# Responses to Comments on Draft Environmental Impact Report

## For the San Francisco Public Utilities Commission's Regional Groundwater Storage and Recovery Project

July 9, 2014

Case No. 2008.1396E

*This page left intentionally blank*

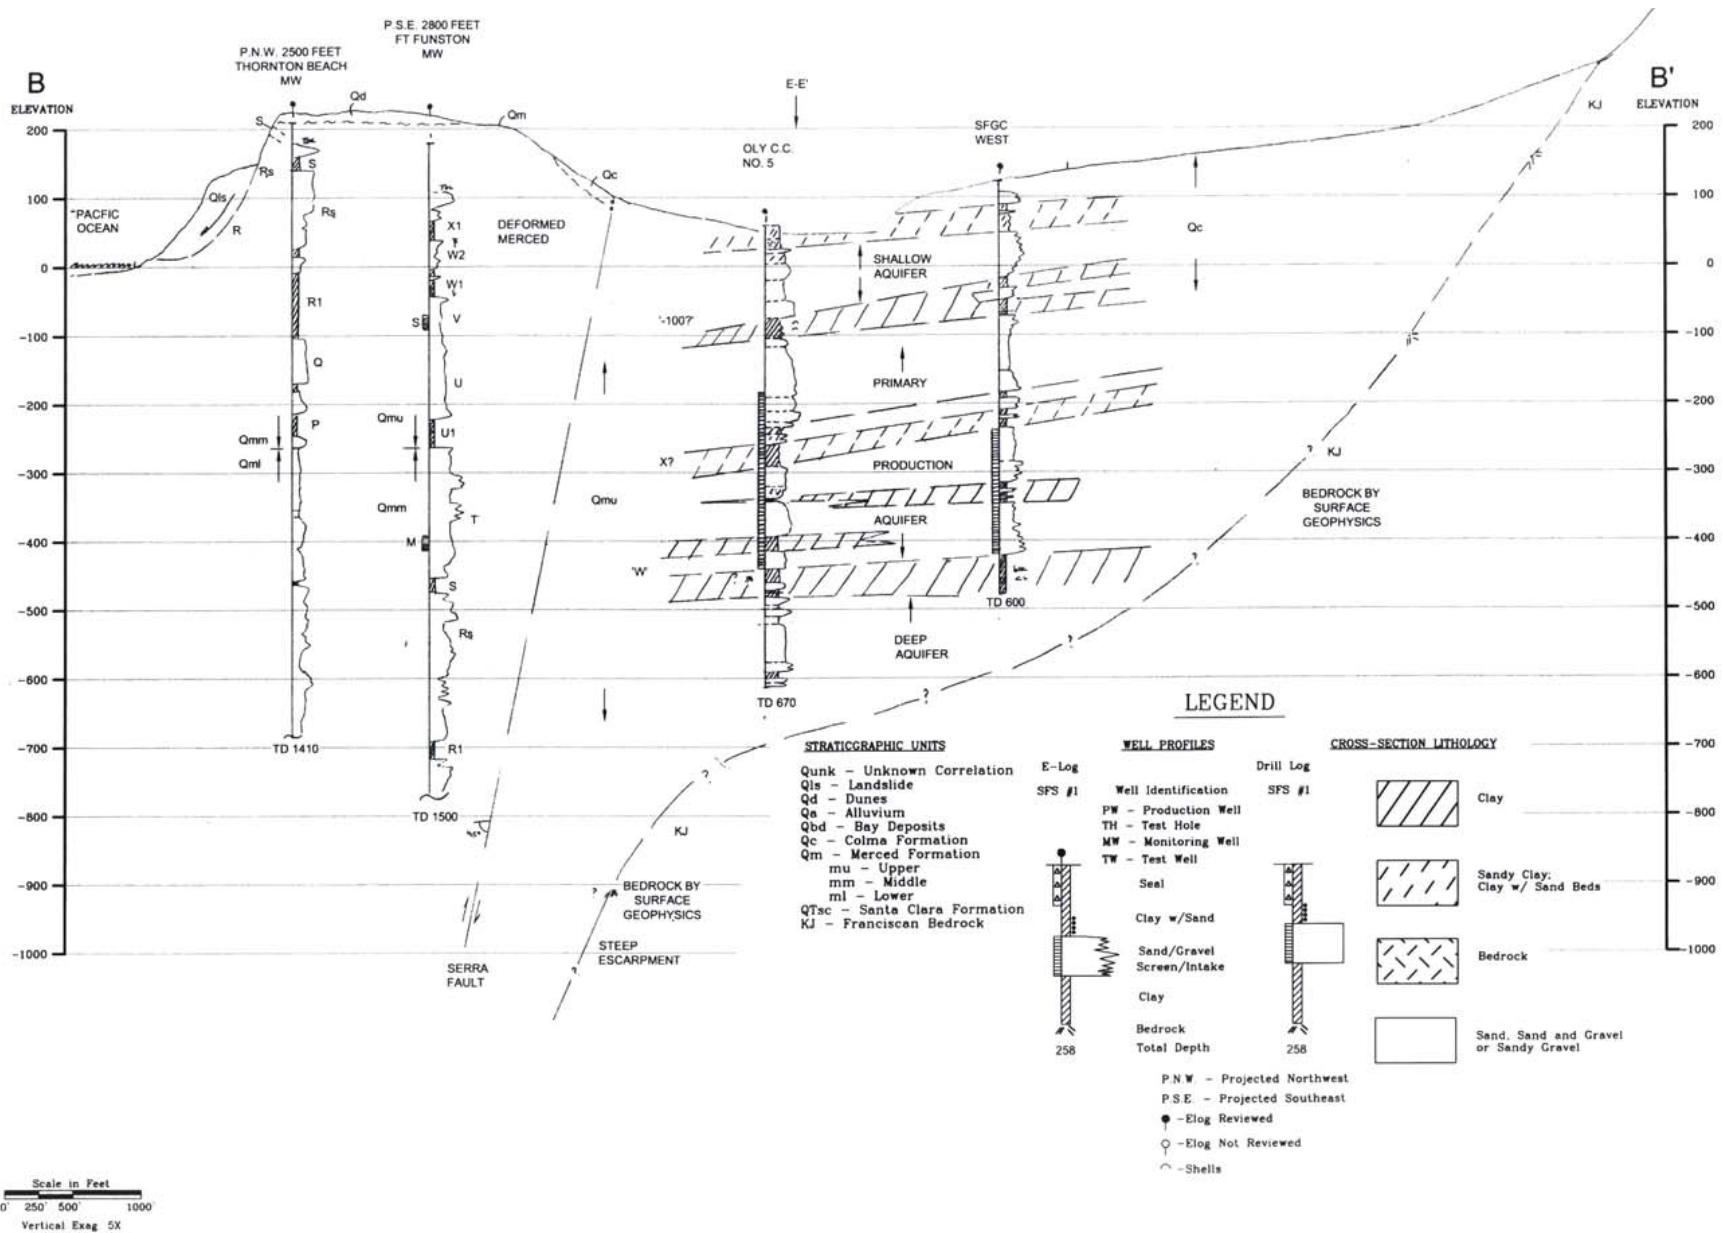
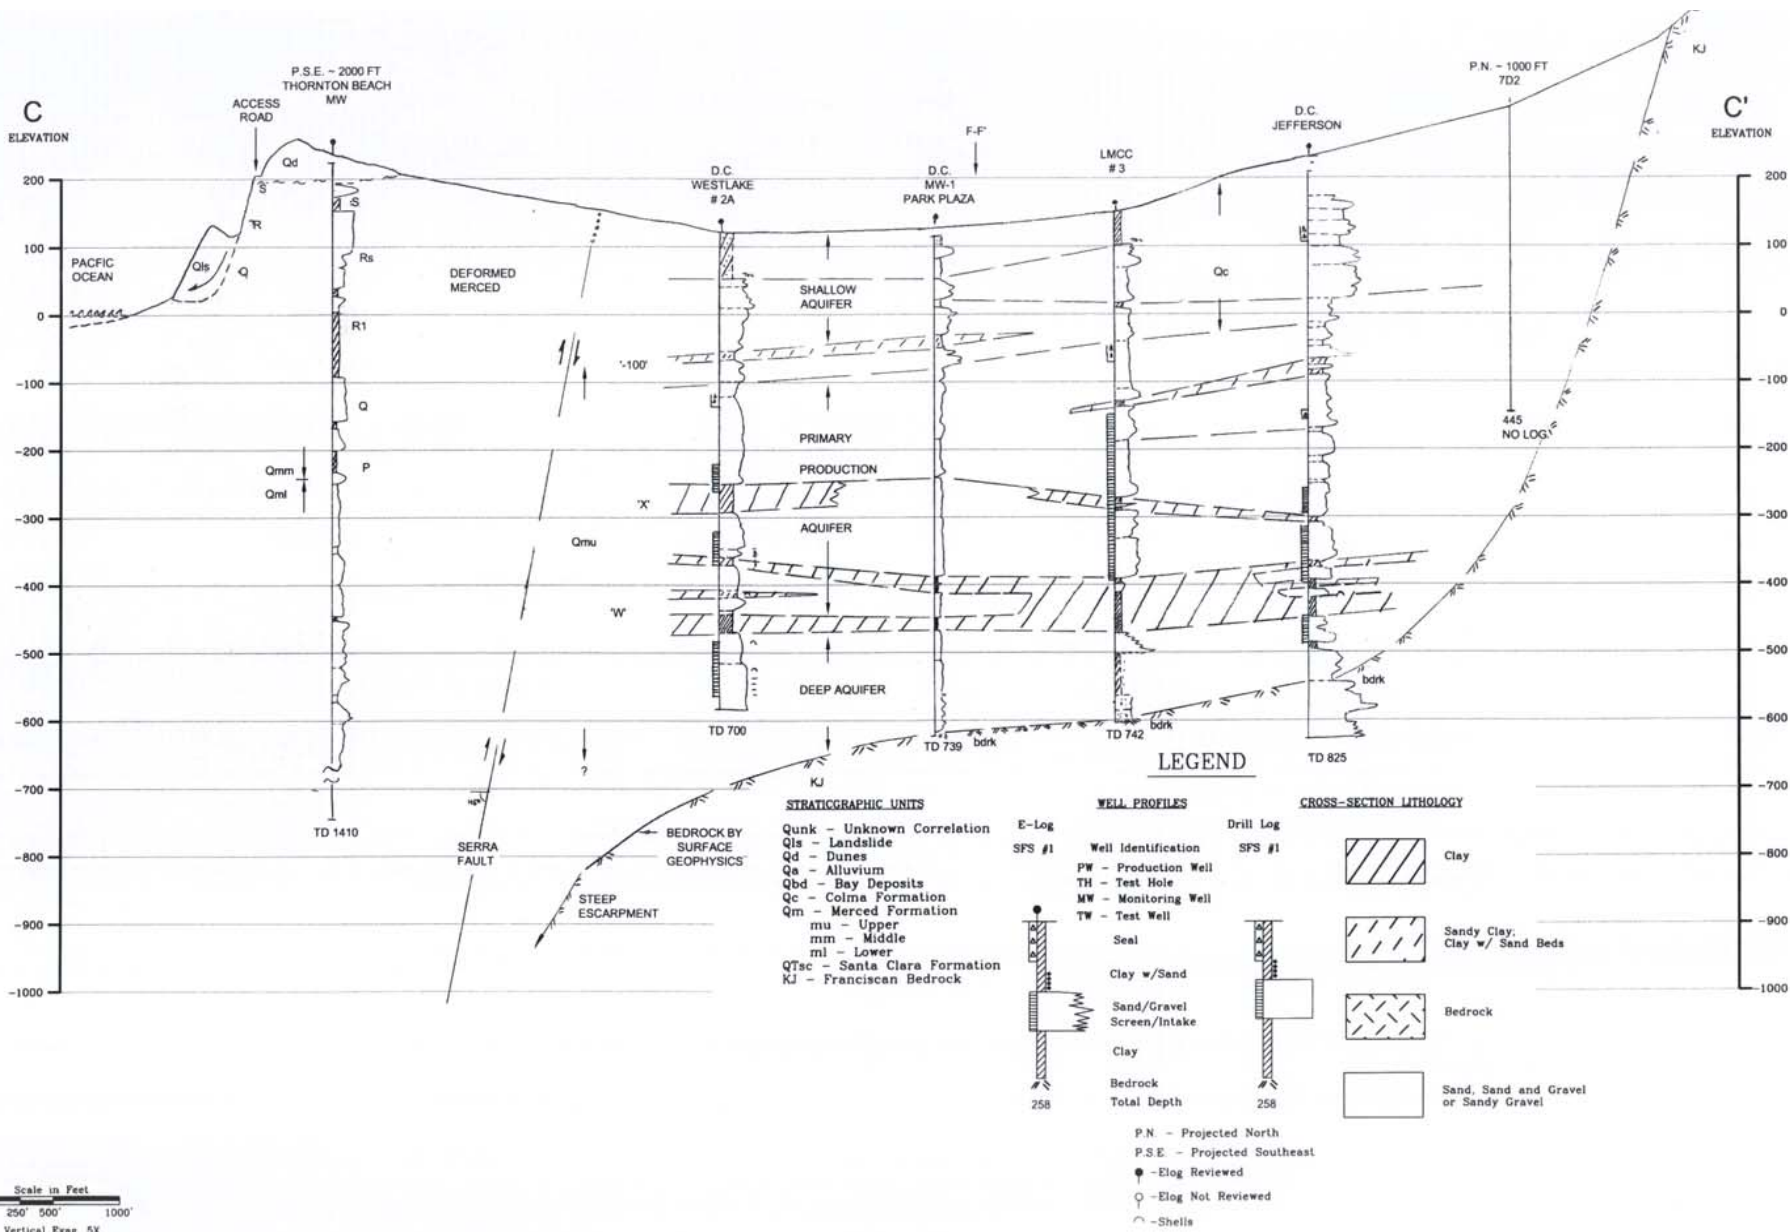
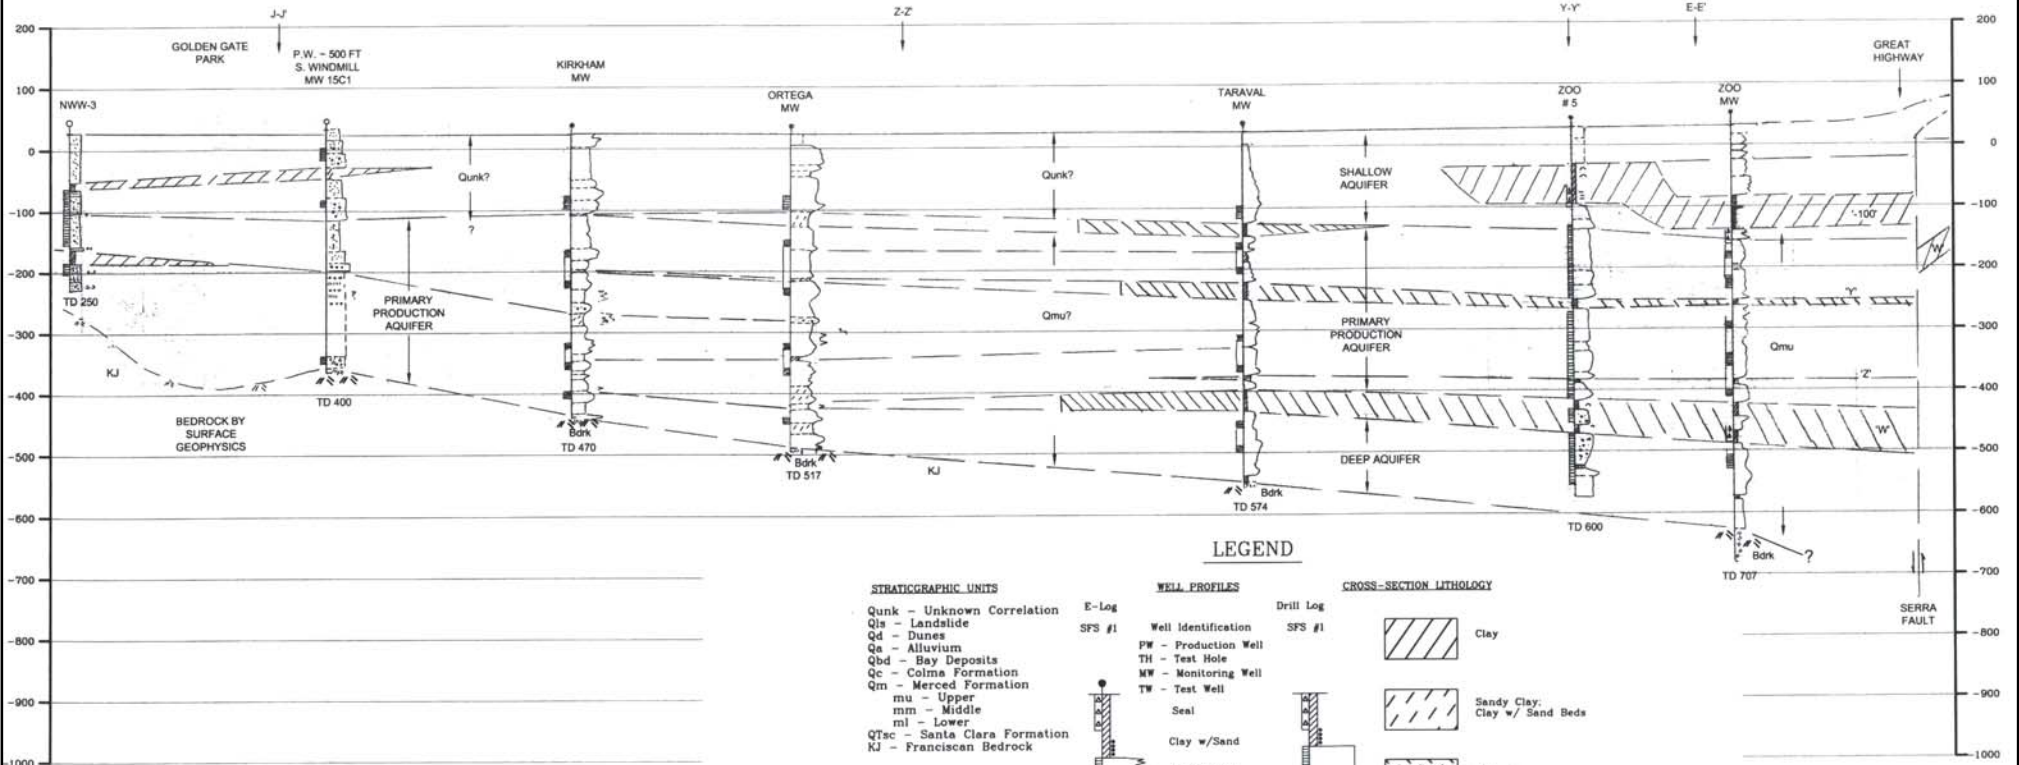
“Item 32 – Why were water levels not included on the cross section?”

The DEIR discusses the water level variability across the Westside Basin and between the various aquifers. It would be very useful to see how measured water levels do in fact vary across the basin and between the aquifers.” (*Cypress Lawn Memorial Park, letter, June 11, 2013 [O-CLMP-Quick]*)

The cross-section, Figure 5.16-2 (North-South Geologic Cross Section, Westside Groundwater Basin), included in the Draft EIR, was selected as being most representative of the characteristics of the groundwater basin that are important to understanding the impact analysis. Additional north-south cross-sections of the basin are included in Appendix H, *Task 10.1 Technical Memorandum, Groundwater Modeling Analysis for the Regional Groundwater Storage and Recovery Project and San Francisco Groundwater Supply Project*, Figure 10.1-3 and the TM's Attachment 10.1-H Figure 7. A reference cited in Draft EIR Section 5.16, Hydrology and Water Quality, *TM 1 Hydrologic Setting of the Westside Basin* (LSCE 2010), provides additional existing setting information relative to seawater intrusion. A figure from the 2010 LSCE report shows the relationship of bedrock to the Serra Fault and other geologic features, and several figures from the report include east-west cross-sections which show the relationship of groundwater basin features in the Westside Groundwater Basin both east and west of the Serra Fault. These figures address the information requested by the comment and are included with this response for reference as Figures RTC-1 (Depth to Bedrock) and RTC-2 through RTC-19 (Cross Section Location Map and cross-sections), respectively.

Figure RTC-20

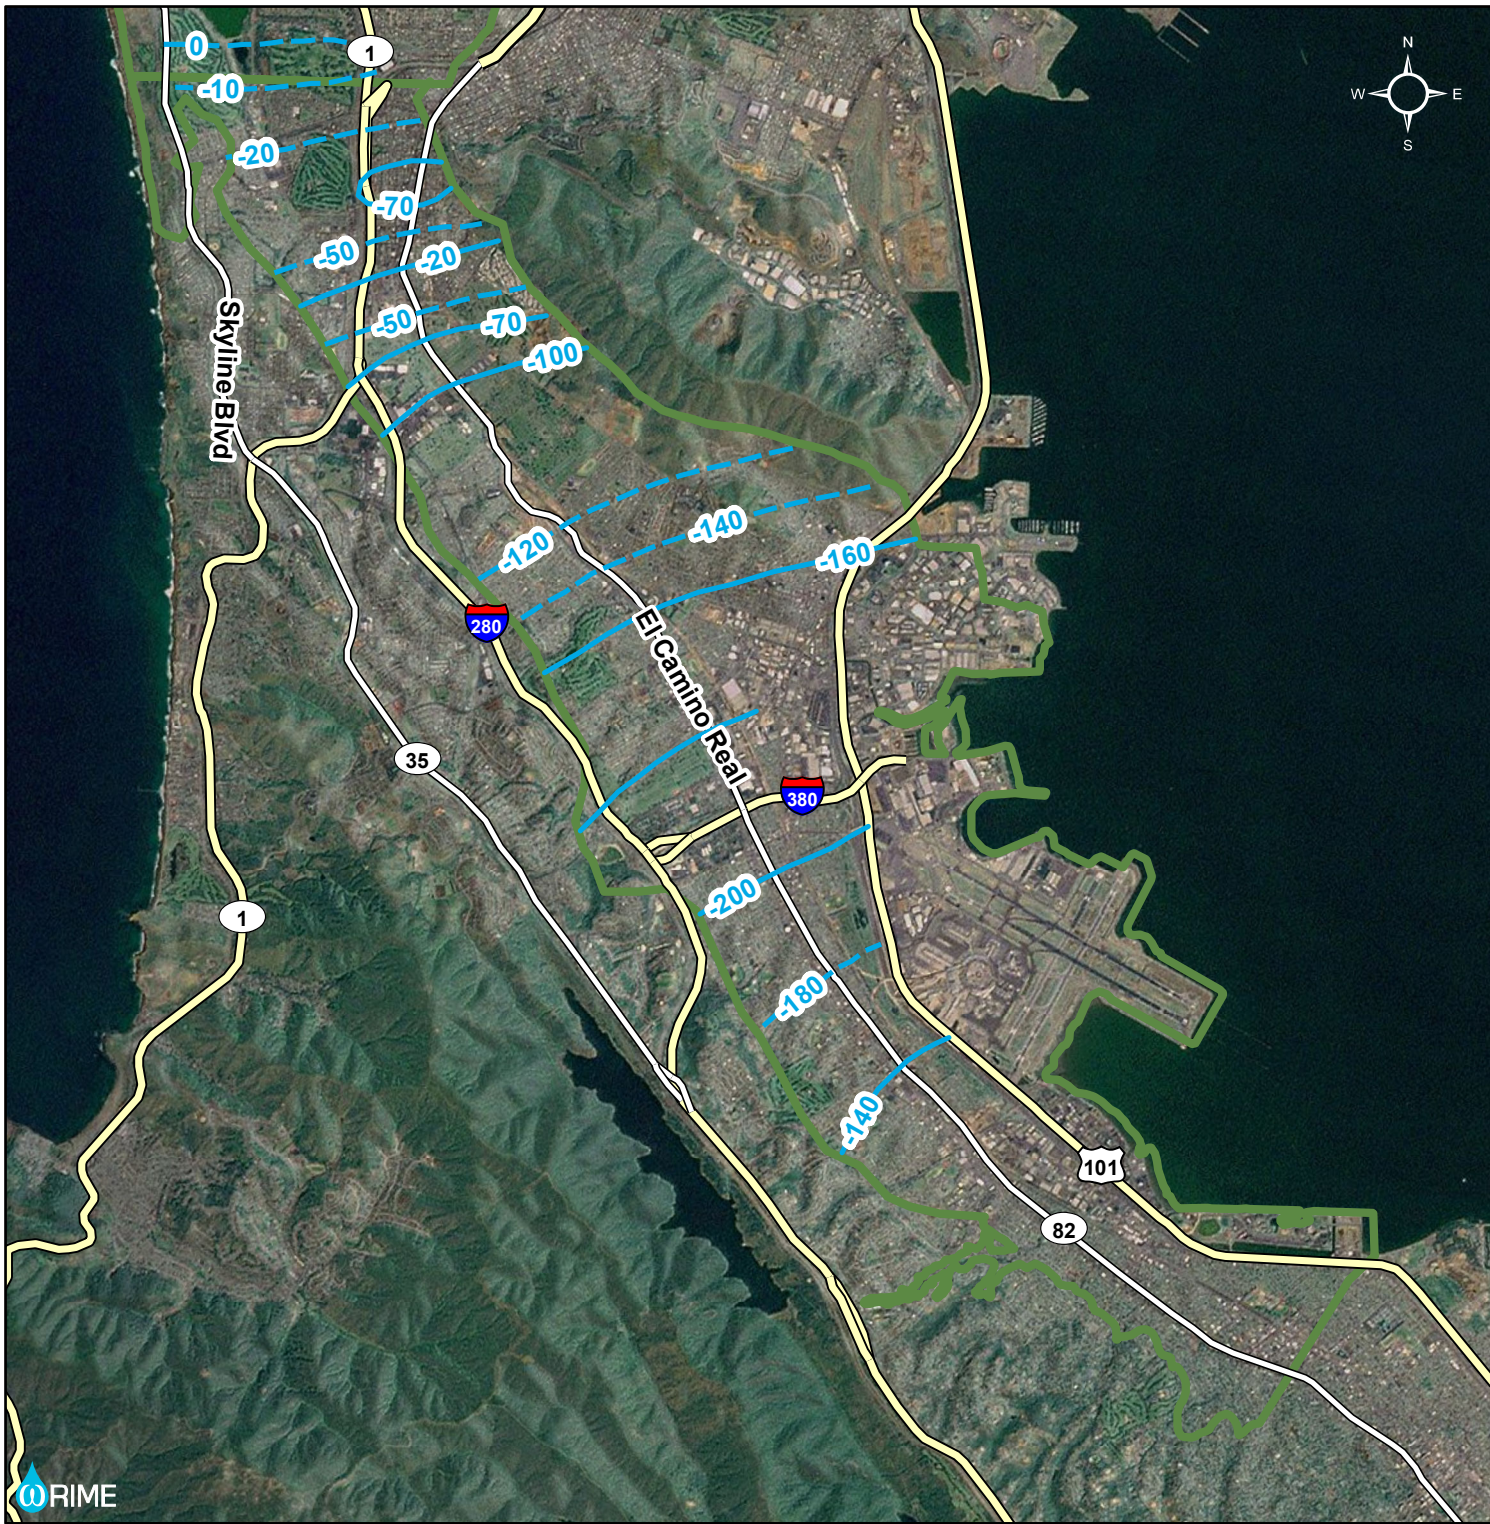
The comment also suggests that measured groundwater levels would be useful if added to the geologic cross-sections. The geologic cross-sections already provide a great deal of information graphically, and the addition of groundwater levels to the cross-sections would add a level of detail that could make the figures more confusing to the reader. Therefore, instead of including this information on those figures, the Draft EIR provides a series of hydrographs which indicate not only the measured groundwater levels at 11 specific locations throughout the Westside Groundwater Basin, but also the groundwater levels under modeled existing conditions (the levels predicted by the model to occur over a variety of rainfall years consistent with the 47 years of historic hydrology). See Appendix H, *Task 10.4 Technical Memorandum, Changes in Groundwater Levels and Storage for the Regional Groundwater Storage and Recovery Project and San Francisco Groundwater Supply Project*, Figures 10.4-3a through 10.4-13b.

Generalized groundwater levels in the South Westside Groundwater Basin for the Primary Production Aquifer are shown in Figure RTC-20 (Groundwater Elevation, Contours Primary Production Aquifer, Fall 2010). Please also see Draft EIR, Appendix H, *Task 10.1 Technical Memorandum, Groundwater Modeling Analysis for the Regional Groundwater Storage and Recovery Project and San Francisco Groundwater Supply Project*, Attachment 10.1-F Model Scenario Groundwater Elevation Contour Map for selected time periods and *Task 10.6 Technical Memorandum, Assessment of Groundwater Quality for the Regional Groundwater Storage and Recovery Project and the San Francisco Groundwater Supply Project*, Attachment 10.6-A, Model Scenario Hydrographs for Selected Locations, which includes groundwater contour maps in Figures 10.6-7 through 10.6-11. The SFPUC's Annual Westside Basin Groundwater Monitoring Reports also include actual measured maps (SFPUC 2013).
